Access Compliance Report

Public Rights-of-Way

Intersection ID: 22250	Main Street: SHARON_LAKES_RD	Cross Street: SOUTH_BV	Location: SW
ADA ID: CC8E87DEE005	Ramp Type: Perp	Initial Pass/Fail: Fail	Overall Compliance: No
Severity Score: 46.25			
Codes/Mitigation Info/Possible Solution		Field Measurements/Component Compliance

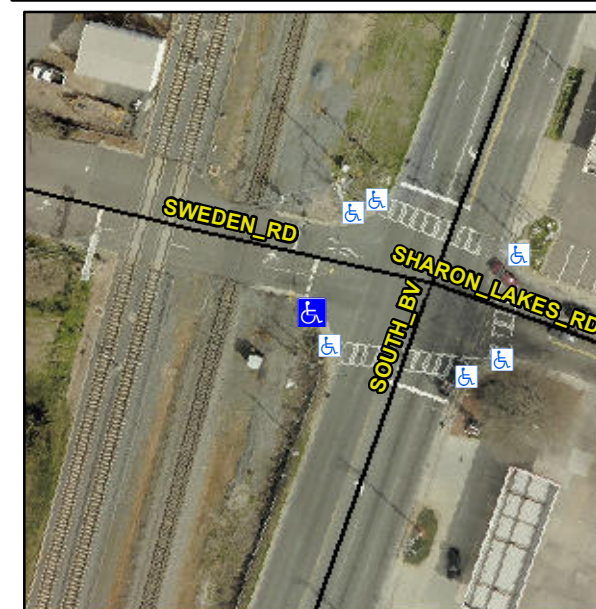
Not Found, R304.5.1, R304.2.2, R304.5.3

Compliance	Description	Data	Compliance	Description	Data
N/A	Ramp Length (in)	48.0	No	Ramp Slope (%)	12.6
No	Ramp Width (in)	39.0	No	Ramp XSlope (%)	6.7
N/A	Flare Type LT	N/A	N/A	Flare Type RT	N/A
N/A	Flare Slope LT (%)	N/A	N/A	Flare Slope RT (%)	N/A
N/A	Flare Traversable LT?	N/A	N/A	Flare Traversable RT?	N/A
N/A	Landing Length (in)	N/A	N/A	DWS Provided?	N/A
N/A	Landing Width (in)	N/A	N/A	DWS Contrast?	N/A
N/A	Landing Slope (%)	N/A	N/A	DWS Length (in)	N/A
N/A	Landing X Slope (%)	N/A	N/A	DWS Full Width?	N/A
N/A	Landing Curb? (Y/N)	N/A	N/A	DWS Offset (in)	N/A
N/A	Shared Landing?	N/A			
N/A	Gutter Ponding?	N/A	N/A	Gutter Slope (%)	N/A
N/A	Gutter Lip Ht (in)	N/A	N/A	Gutter X Slope (%)	N/A
N/A	Painted X Walk1?	No	N/A	Painted X Walk2?	N/A
	X Walk 1 Direction	To NE		X Walk 2 Direction	N/A
N/A	X Walk 1 Width (in)	N/A	N/A	X Walk 2 Width (in)	N/A
	X Walk 1 Slope (%)	2.5		X Walk 2 Slope (%)	N/A
	X Walk 1 X Slope (%)	7.7		X Walk 2 X Slope (%)	N/A

Remove & Replace Entire Ramp.
